ADDENDUM #3

C20004 – US 101/BLOSSOM HILL ROAD INTERCHANGE IMPROVEMENT

ISSUE DATE: APRIL 28, 2020

CONSTRUCTION DETAILS

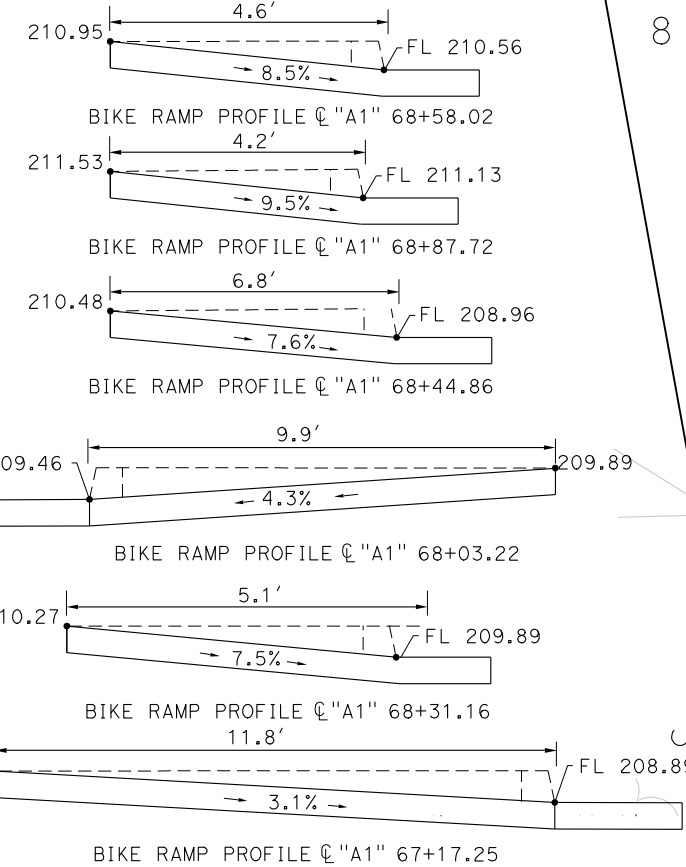
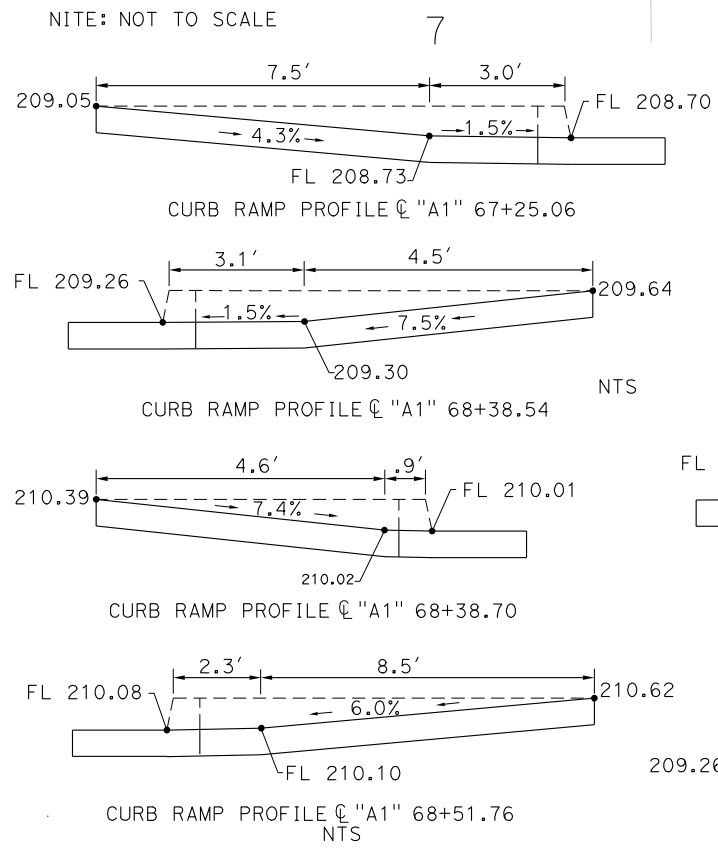
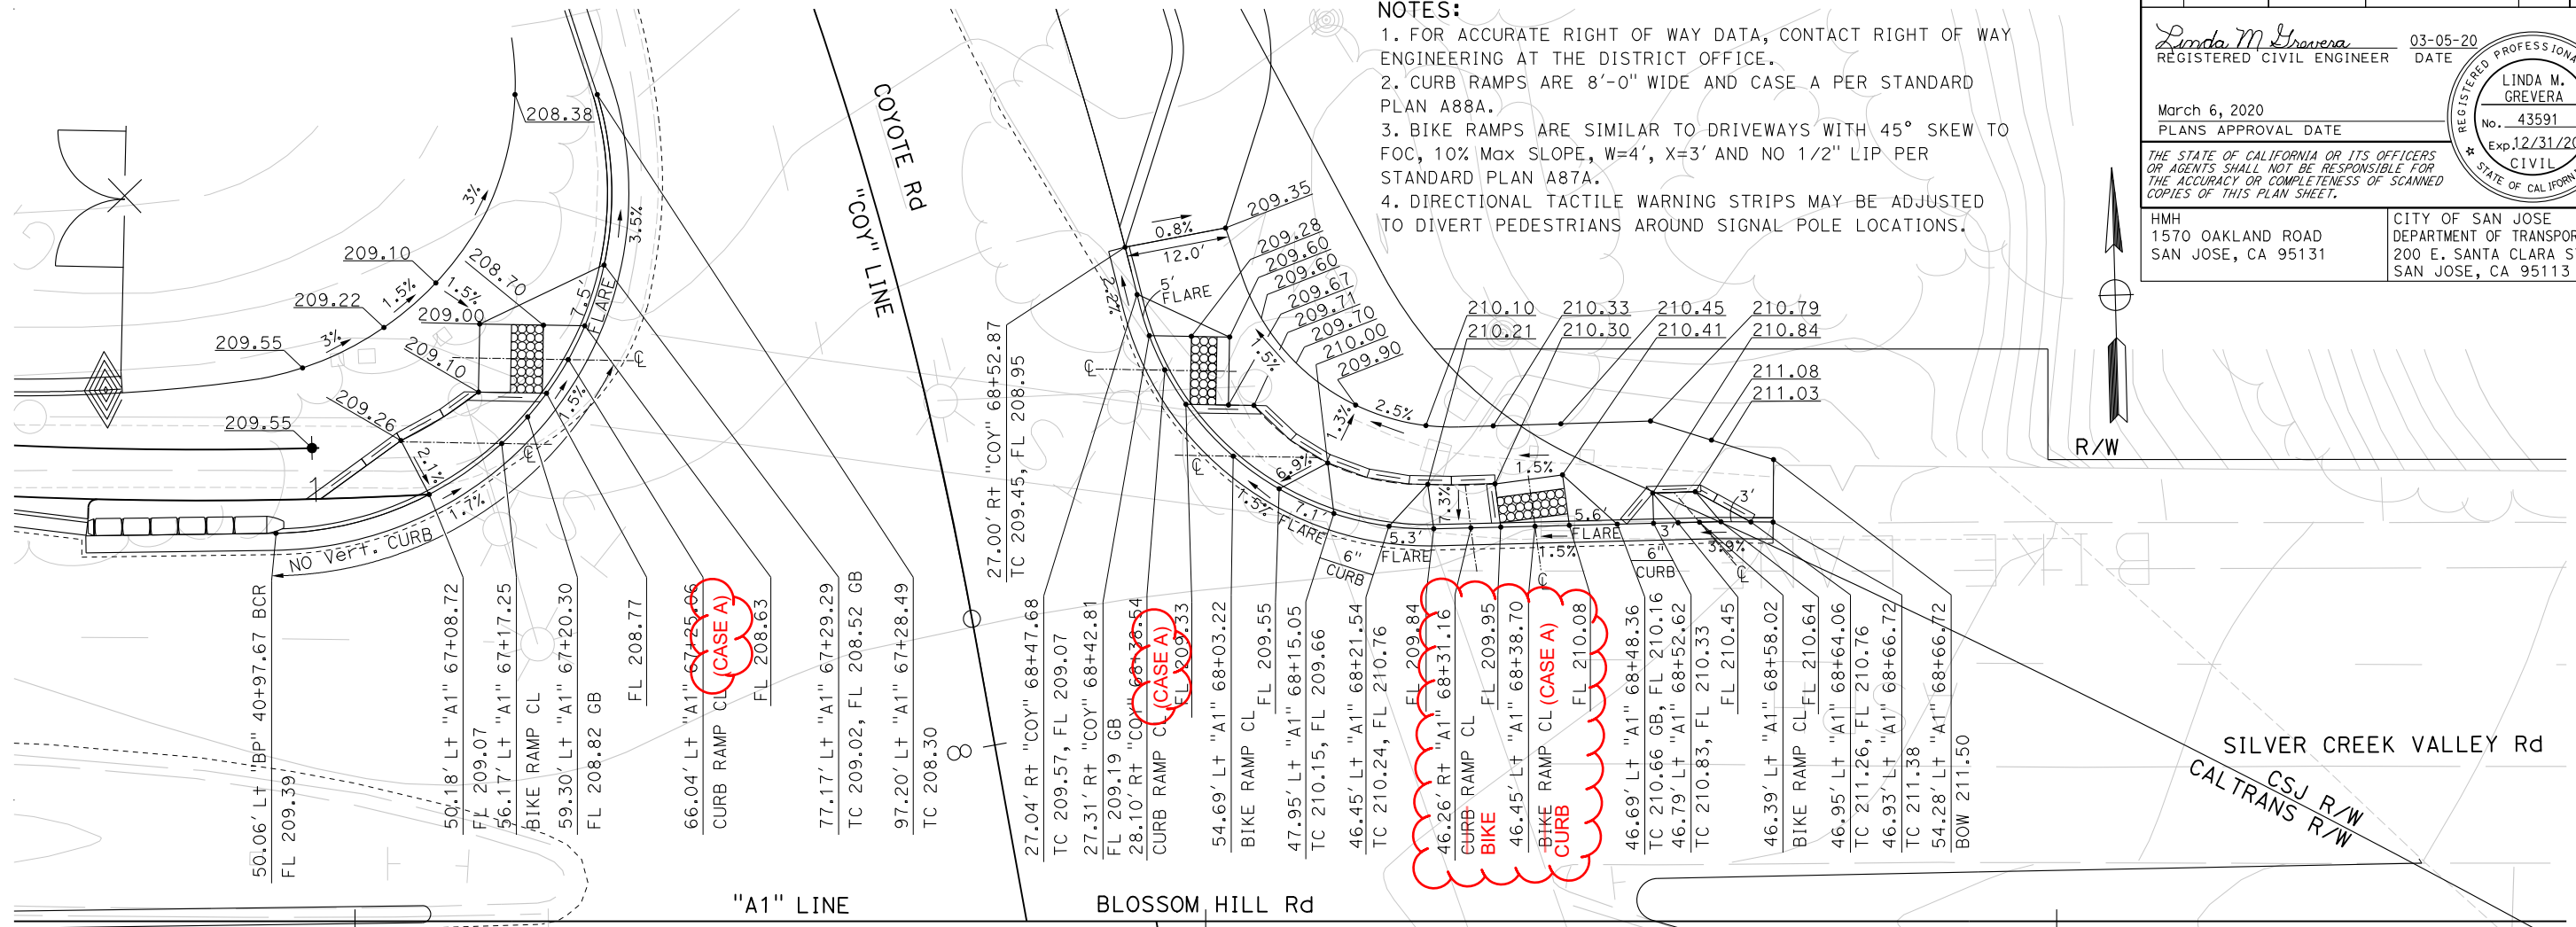
6. **REPLACE** drawing C-27 with the attached revised drawing C-27

ADDENDUM #3
SOUND WALL PLAN
WALL No. 1
SCALE AS SHOWN

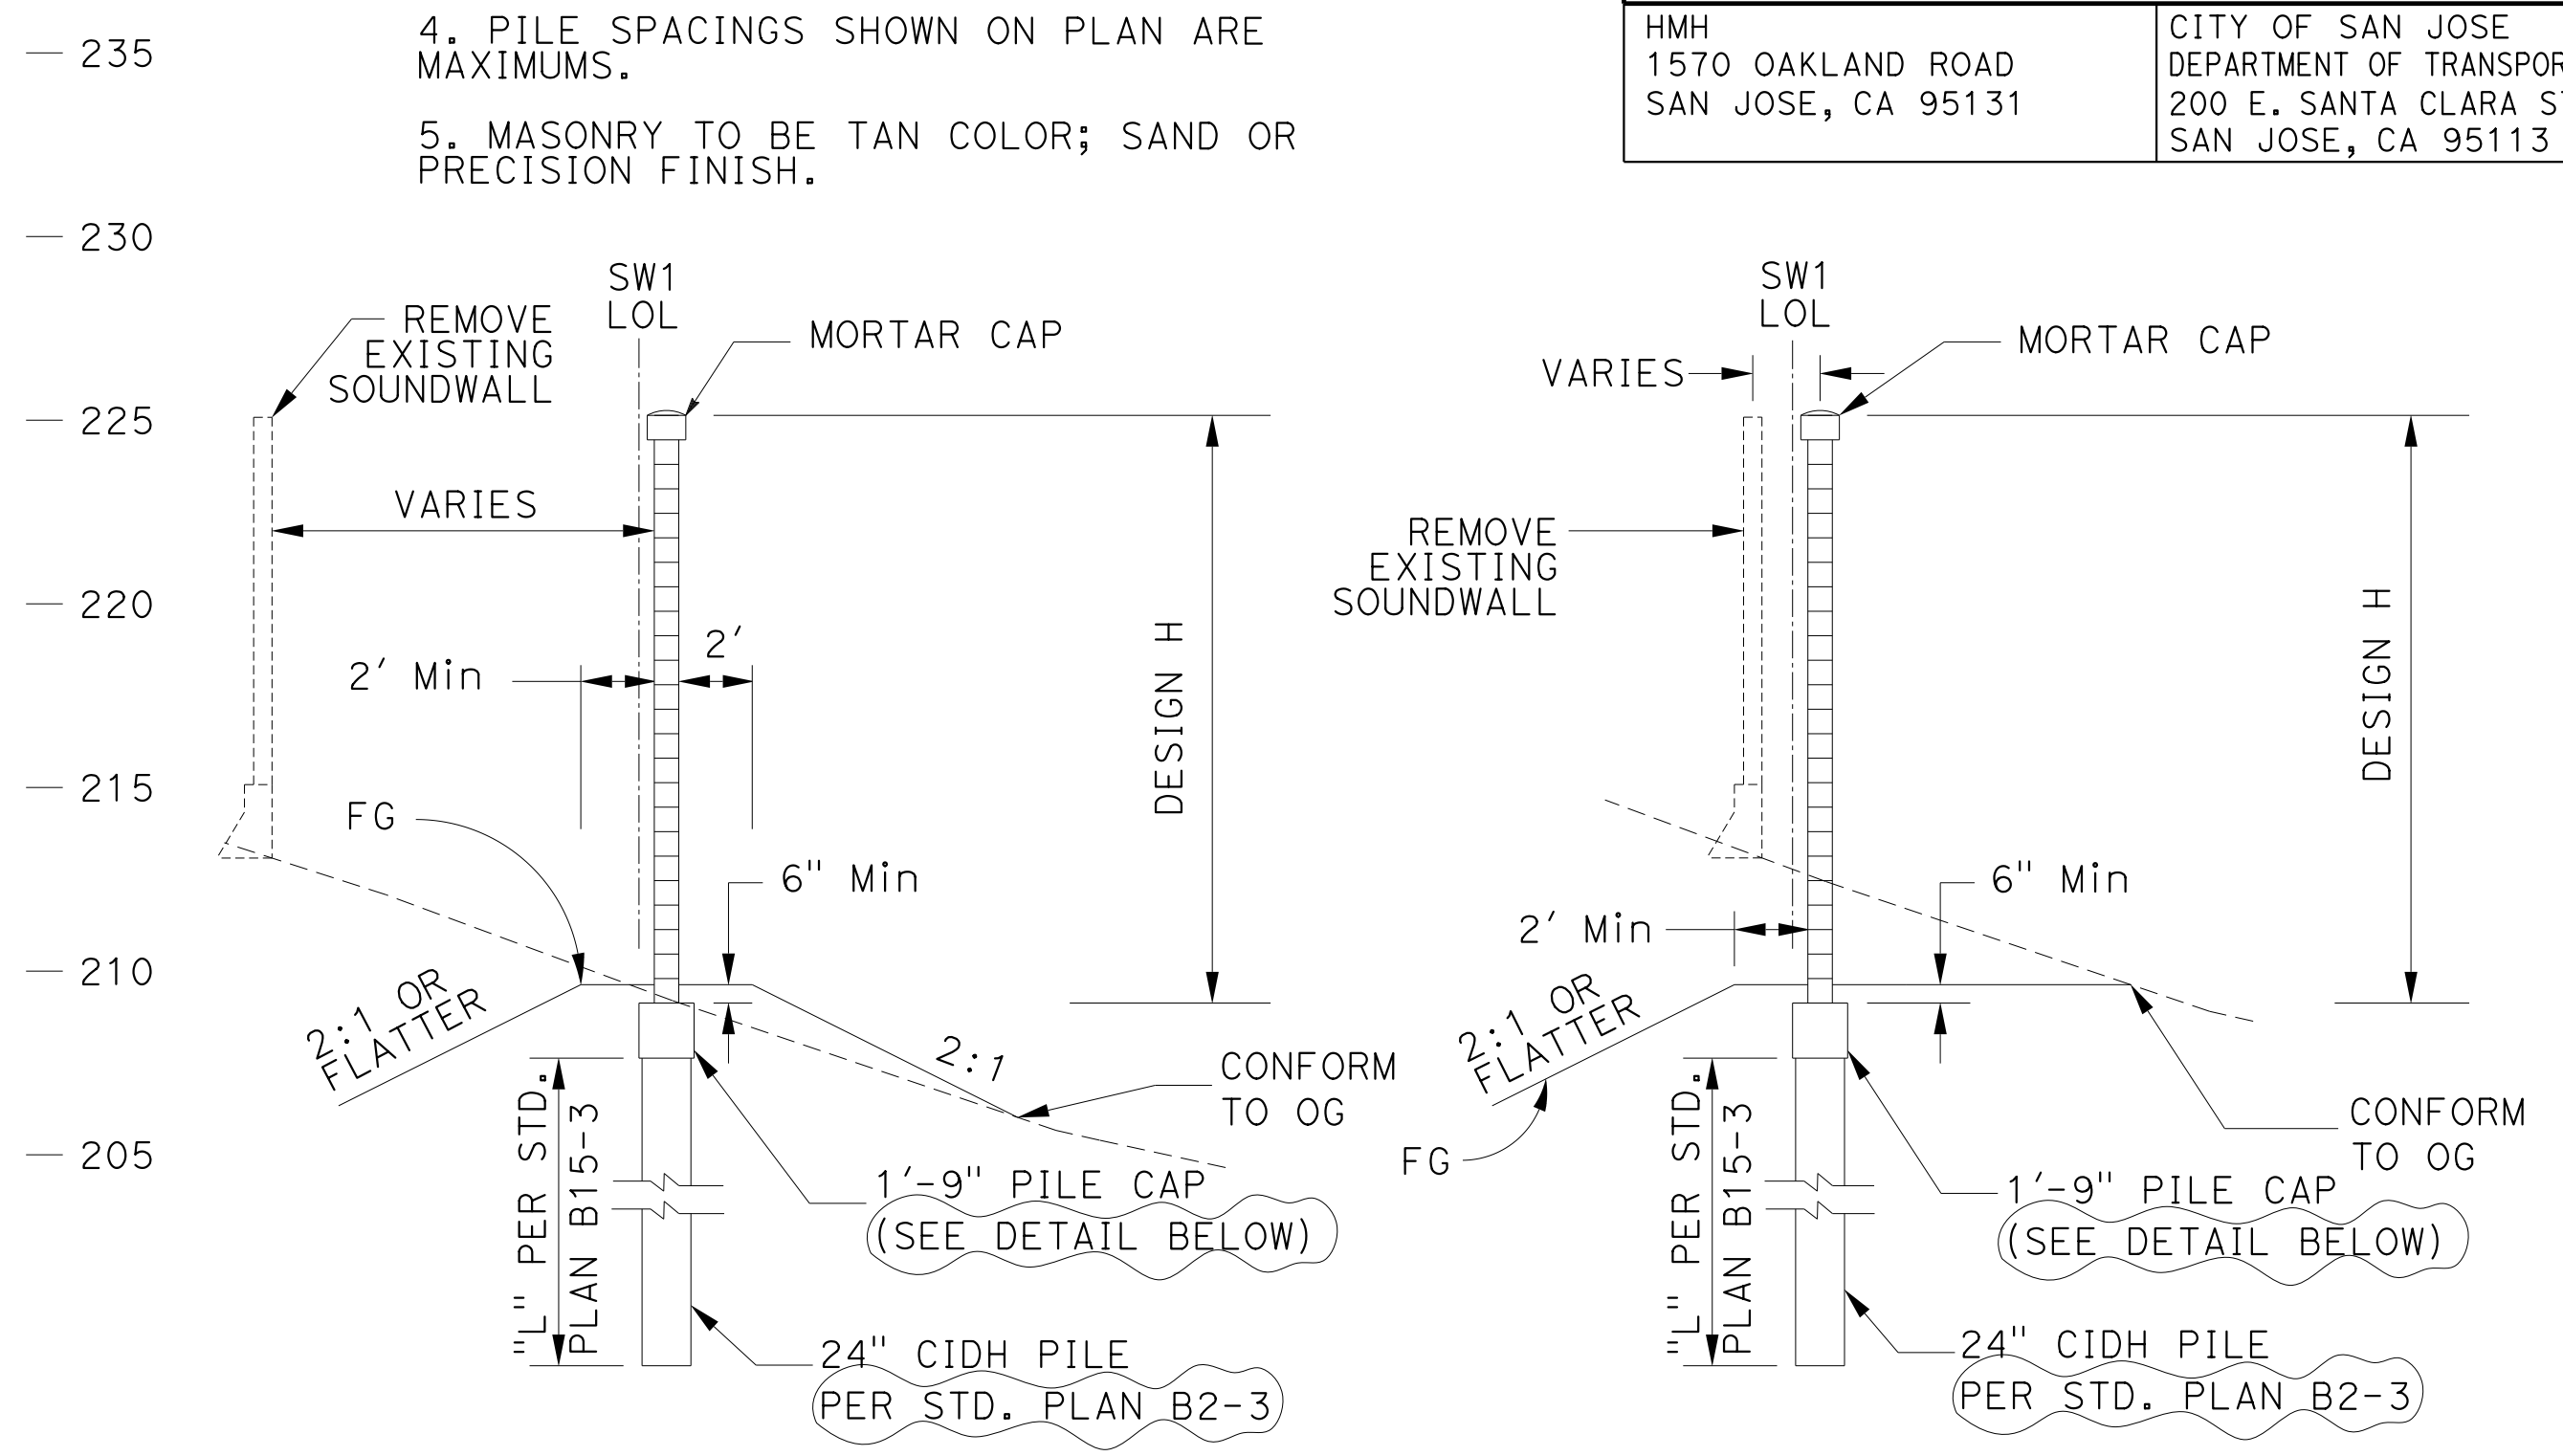
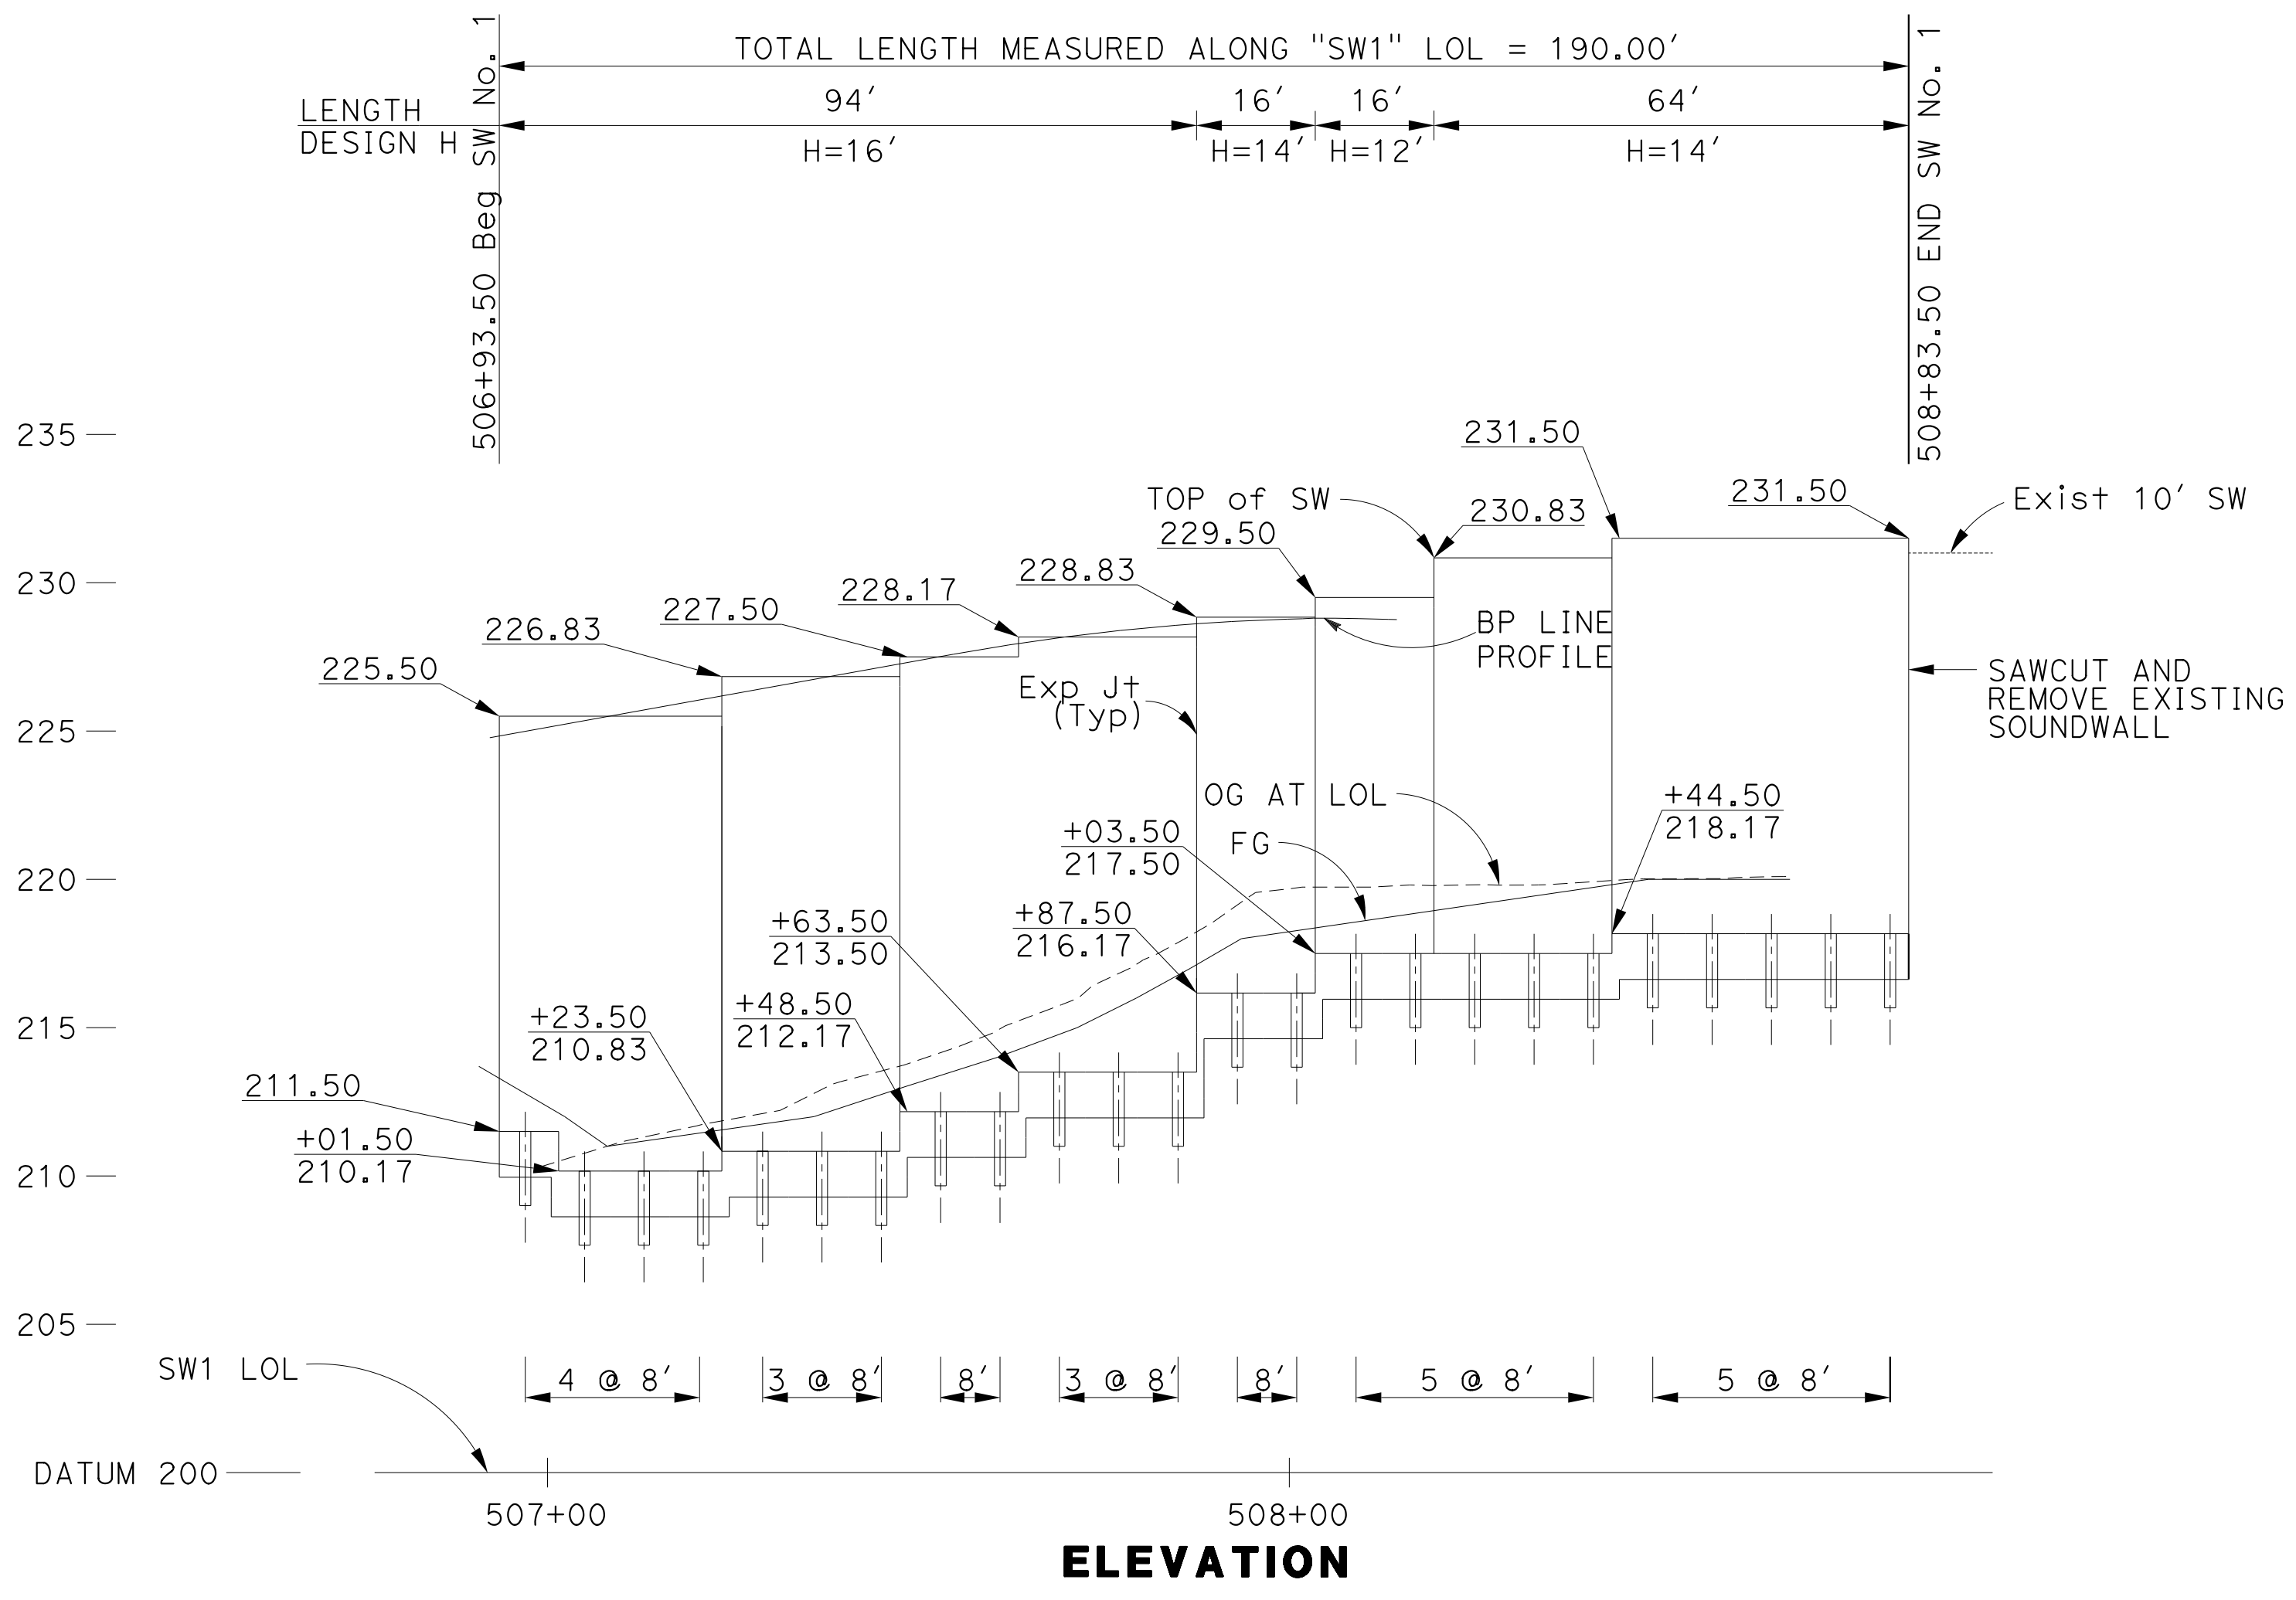
9. **REPLACE** drawing SW-1 with the attached revised drawing SW-1.
